| Intersection ID: 25032 | Main Street: CARMEL_RD | Cross Street: SHADOWLAKE_DR | Location: | W |
| ADA ID: 709351BEC4A5 | Ramp Type: PerpDiag | Initial Pass/Fail: Fail | Overall Compliance: No | Severity Score: 10 |

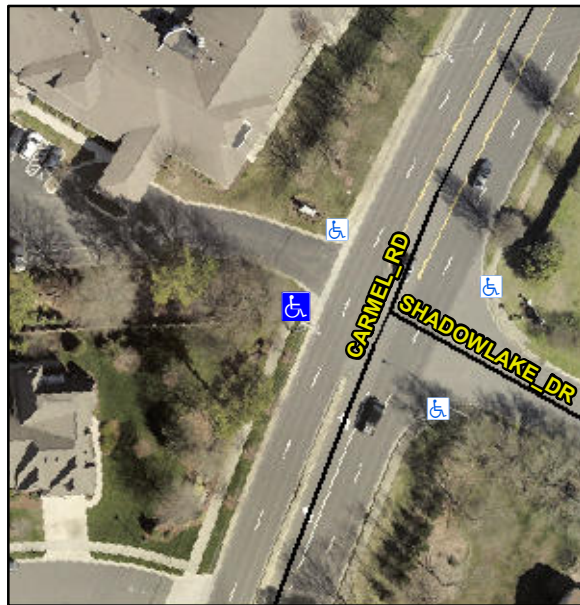
R304.5.1, R304.5.3

| Compliance | Description | Data | Compliance | Description | Data |
|------------|-----------------------|-------|------------|-----------------------------|-------|
| No | Ramp Width (in) | 46.0 | No | Ramp XSlope (%) | 3.0 |

Remove & Replace Curb Ramp With Two New Directional Ramps or Equivalent.
